Re: Docket No. 50-275, OL-DPR-80  
Docket No. 50-323, OL-DPR-82  
Diablo Canyon Units 1 and 2  
Revised Response to IEIR 50-275/87-19 and 50-323/87-19  
Safeguards Notice of Violation

Revised Response to IEIR 50-275/87-19 AND 50-323/87-19  
Safeguards Notice of Violation

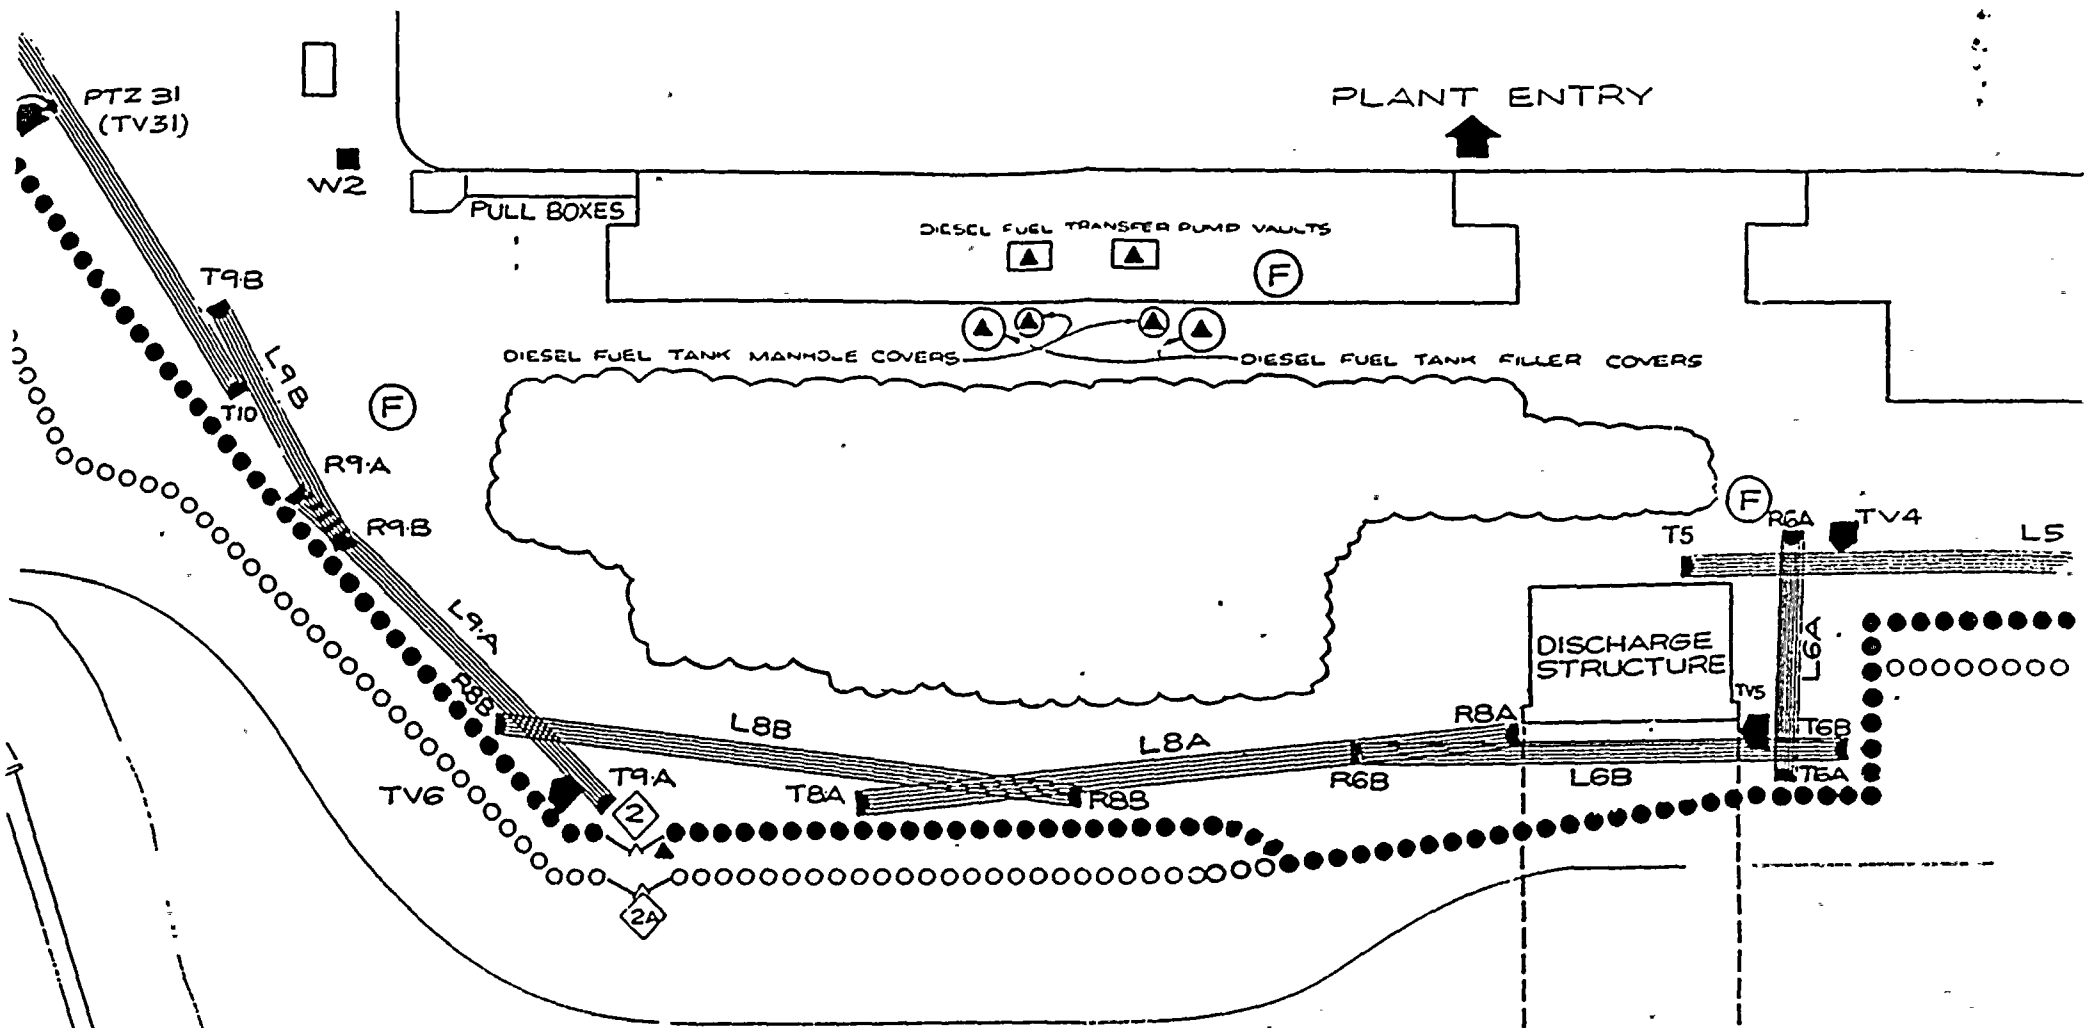
Contrary to the above, on May 4, 1987, there were four separate areas (totaling approximately 110 feet) along the protected area perimeter which were not capable of being viewed by any of the CCTV cameras. As a result, the video consoles in the CAS and SAS were unable to view these four separate areas of the plant perimeter.

1. CCTV Camera 4 has been realigned and now views the fence line south of the discharge structure.
2. CCTV Camera 5 in front of the discharge structure has been realigned to improve fence line observation. A gap in CCTV coverage still exists in this area, however, an appropriate compensatory measure has been taken until permanent corrective action is completed.
3. The angle in the fence line north of CCTV Camera 5 has been removed, thus, this section of fence line is now under CCTV observation.
4. CCTV Camera 6 has been realigned and now covers the gap at the base of CCTV Camera 31.

NOTE: Refer to the attached figure which reflects the changes identified above.
